ADDENDUM

ADDENDUM#: 1
DATE: 2017-Oct-16
FILE #: 163302290

PROJECT NAME: King City Generator Replacement
CLIENT: Environment and Climate Change Canada

1 KING CITY RADAR WEATHER STATION – APU BUILDING PLAN – NEW WORK
M3 1:20

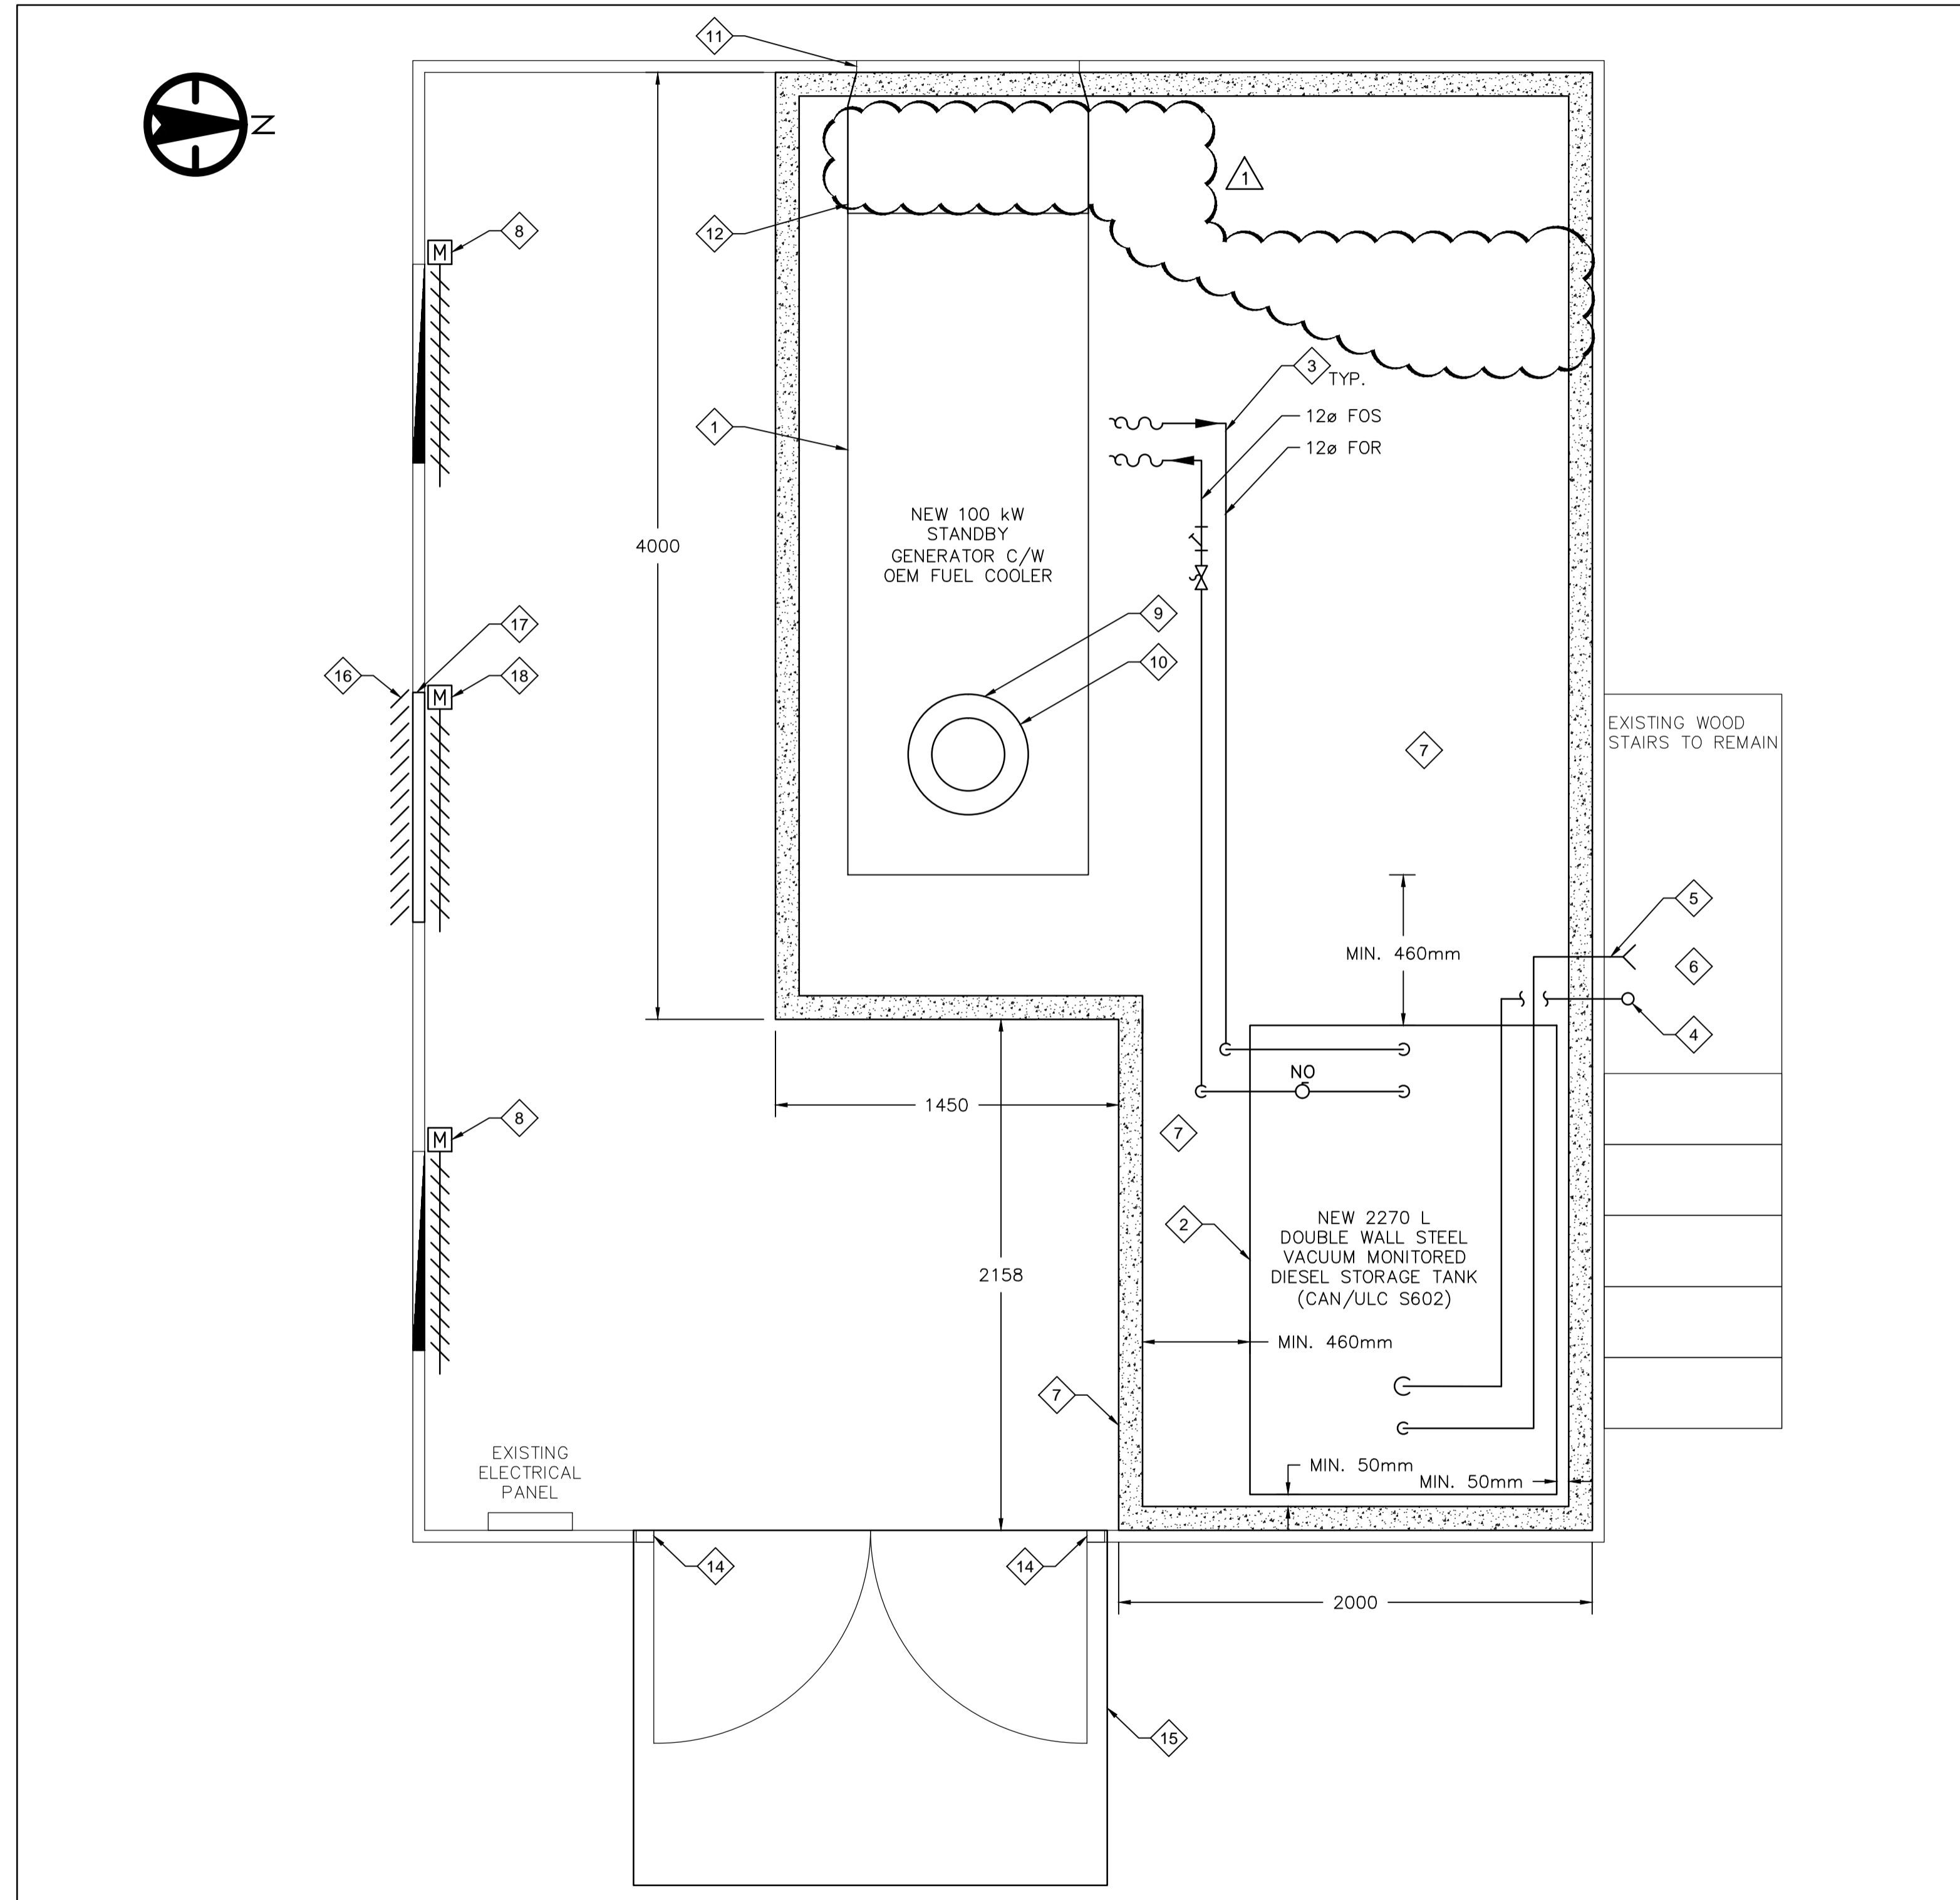
1. **REMOVE** the following from the scope of work:
 - .1 Providing new generator recirculation air control damper c/w related accessories including motorized damper actuator, line voltage temperature sensor and associated power and control wiring.
2. Install generator radiator cooling exhaust air ductwork continuously from generator to existing wall opening as per generator manufacturer's written recommendations.

- PROVIDE NEW DUCTWORK PLENUM TO SUIT NEW 100 kW STANDBY GENERATOR RADIATOR COOLING AIR REQUIREMENTS (3000 L/s) AND EXISTING 940mm x 1240mm WALL OPENING AS PER MANUFACTURER'S RECOMMENDATIONS. INSULATE PLENUM AS PER SPECIFICATIONS.

2
E8 **NEW CONSTRUCTION - GENERATOR SHED - PANEL F SCHEDULE**
N.T.S

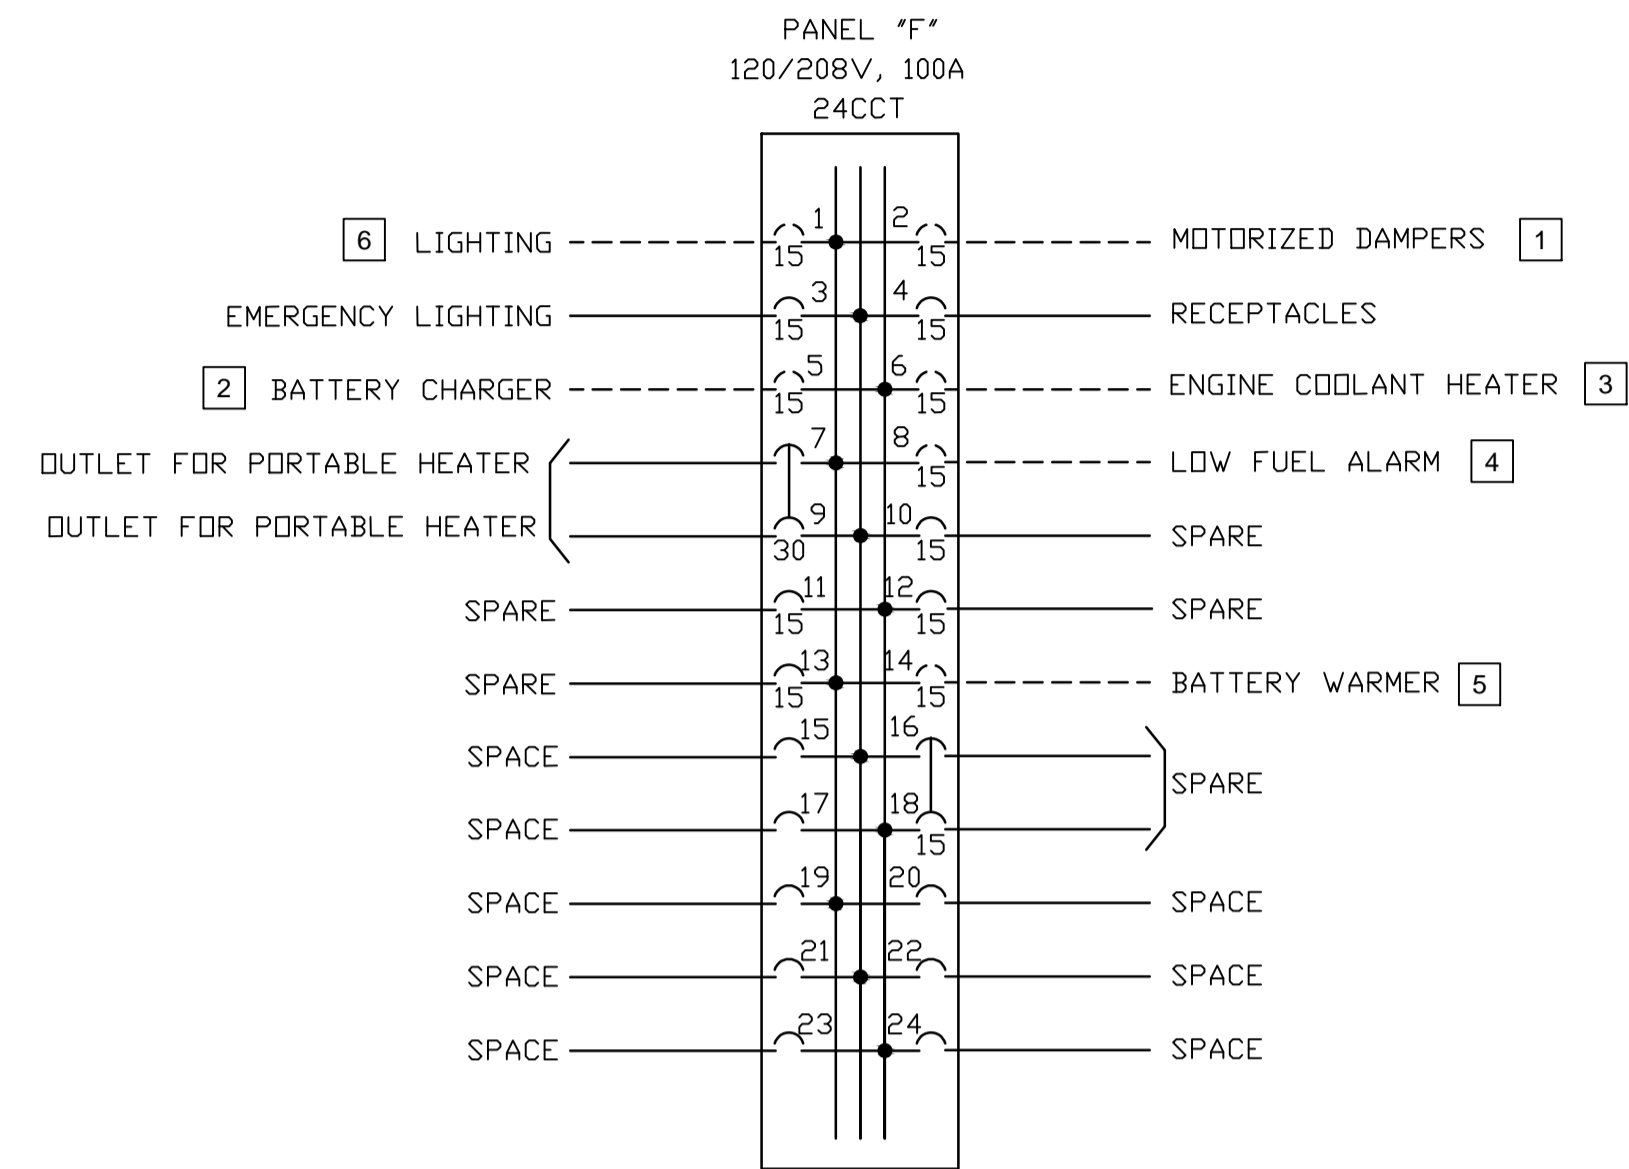
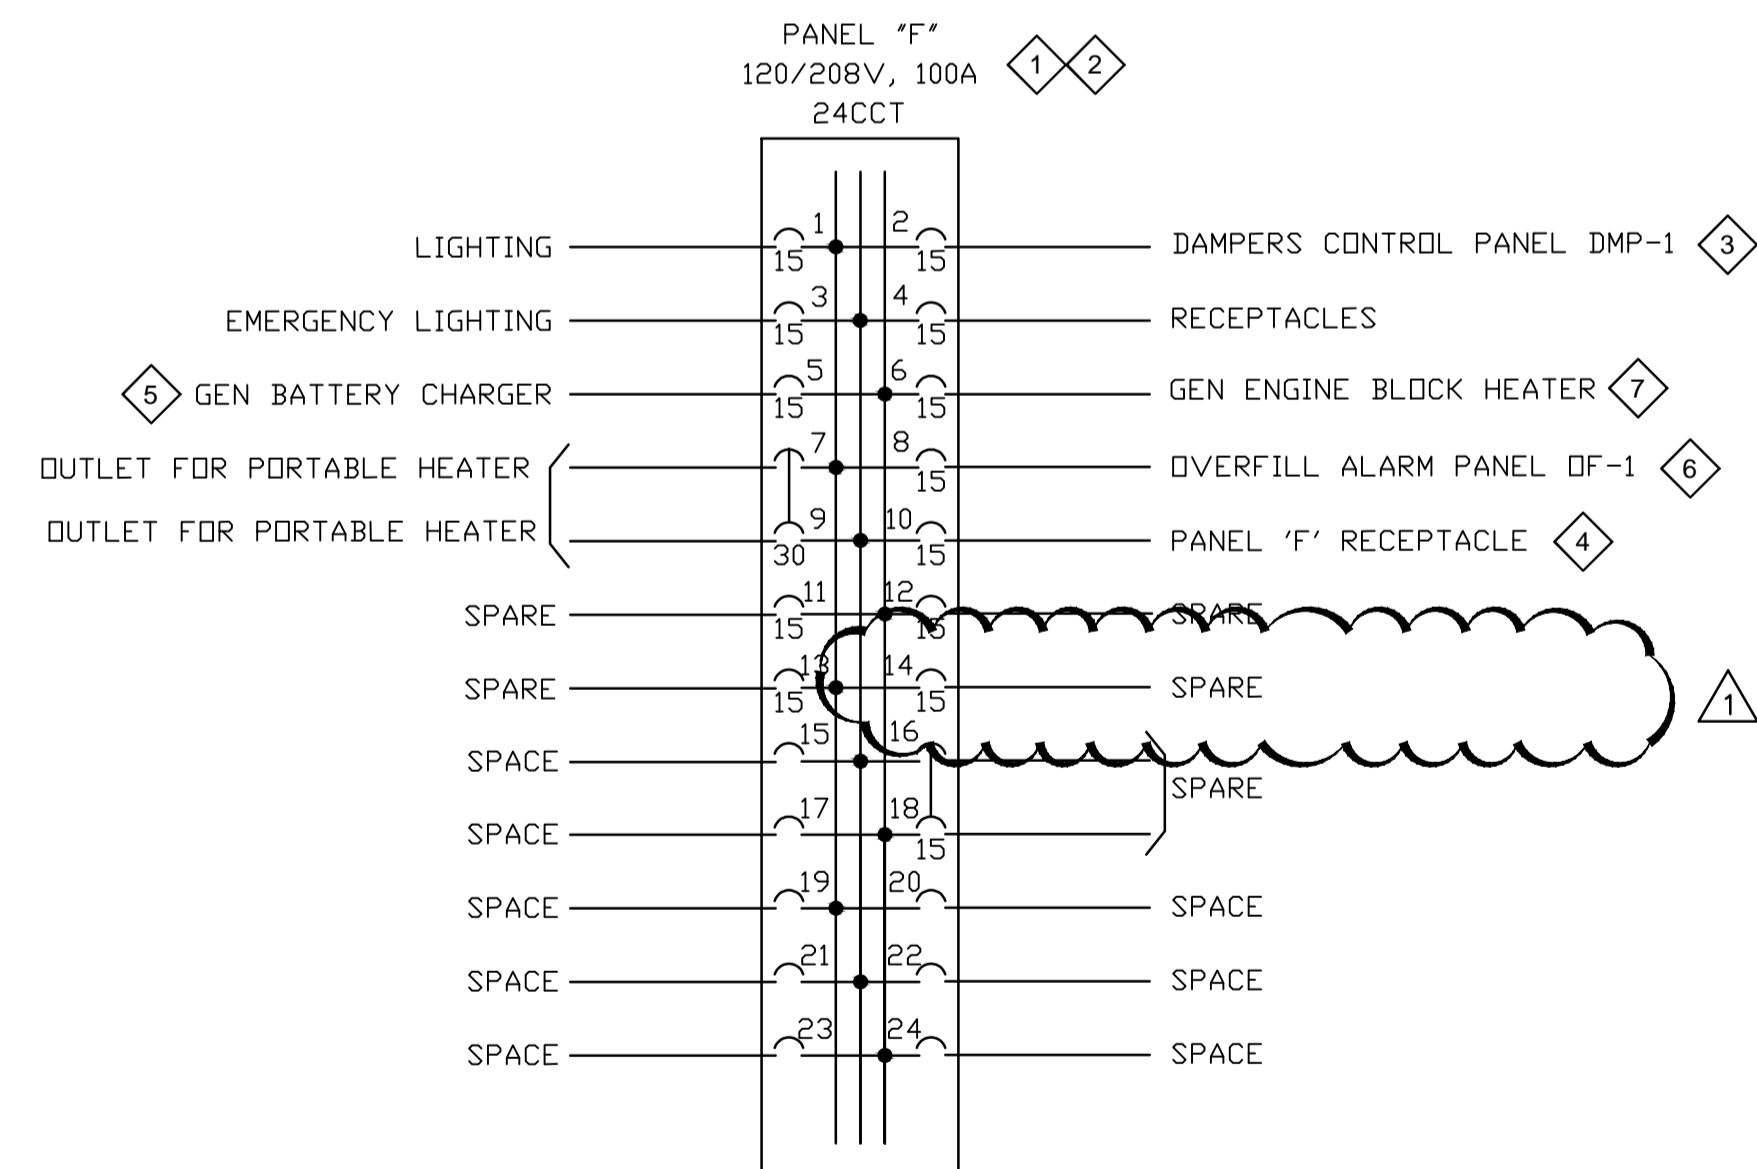
1	UPDATE TYPE WRITTEN PANEL SCHEDULE TO AS-BUILT CONDITION AND PROVIDE COPY IN PANELBOARD.
2	PROVIDE CIRCUIT ID LABEL ON ALL RECEPTACLES TO INDICATE SOURCE CIRCUIT.
3	PROVIDE NEW 2#14AWG T90 + BOND IN 21mm EMT FROM EXISTING CIRCUIT BREAKER IN PANEL 'F' TO NEW MOTORIZED DAMPER CONTROL PANEL DMP-1.
4	PROVIDE NEW 2#14AWG T90 + BOND IN 21mm EMT FROM EXISTING CIRCUIT BREAKER IN PANEL 'F' TO NEW RECEPTACLE.
5	PROVIDE NEW 2#14AWG T90 + BOND IN 21mm EMT FROM EXISTING CIRCUIT BREAKER IN PANEL 'F' TO NEW GENERATOR BATTERY CHARGER.
6	PROVIDE NEW 2#14AWG T90 + BOND IN 21mm EMT FROM EXISTING CIRCUIT BREAKER IN PANEL 'F' TO NEW OVERFILL ALARM PANEL OF-1.
7	PROVIDE NEW 2#14AWG T90 + BOND IN 21mm EMT FROM EXISTING CIRCUIT BREAKER IN PANEL 'F' TO NEW GENERATOR ENGINE BLOCK HEATER.
8	NOT USED
